Groundwater Transfer Review Summary Form

Transfer/PA # T- 14368

Application: T-14368

Applicant Name: Frank and Julie Kline

Well Location Map

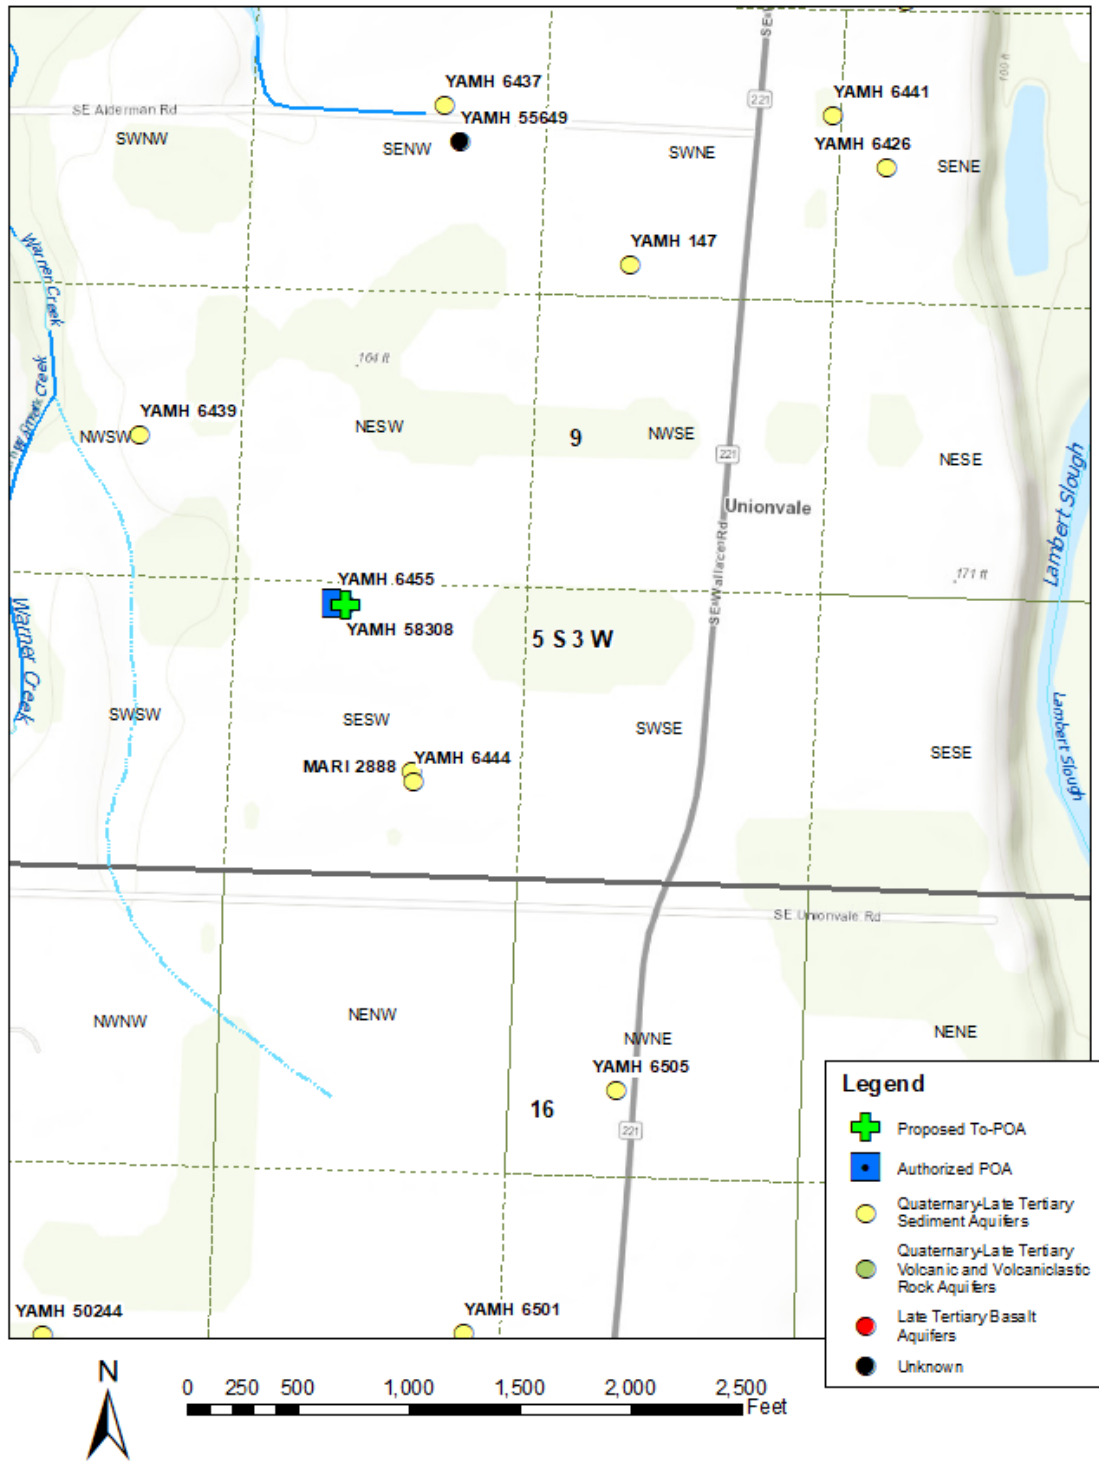
4. a) Will this proposed change, at its maximum allowed rate of use, likely result in an increase in interference with **another ground water right**?
 Yes No Comments: Based on the GPS coordinates provided on the well logs for YAMH 58307 (abandonment of YAMH 6455) and YAMH 58308, the proposed POA is not appreciably closer to other known wells. The proposed change is not likely to result in an increase in interference with another groundwater right.

5. a) Will this proposed change, at its maximum allowed rate of use, likely result in an increase in interference with **another surface water source**?
 Yes No Comments: The proposed POA is located approximately 40 feet east of the authorized POA and is not appreciably closer to a surface water source. The proposed change is not likely to result in an increase in interference with another surface water source.
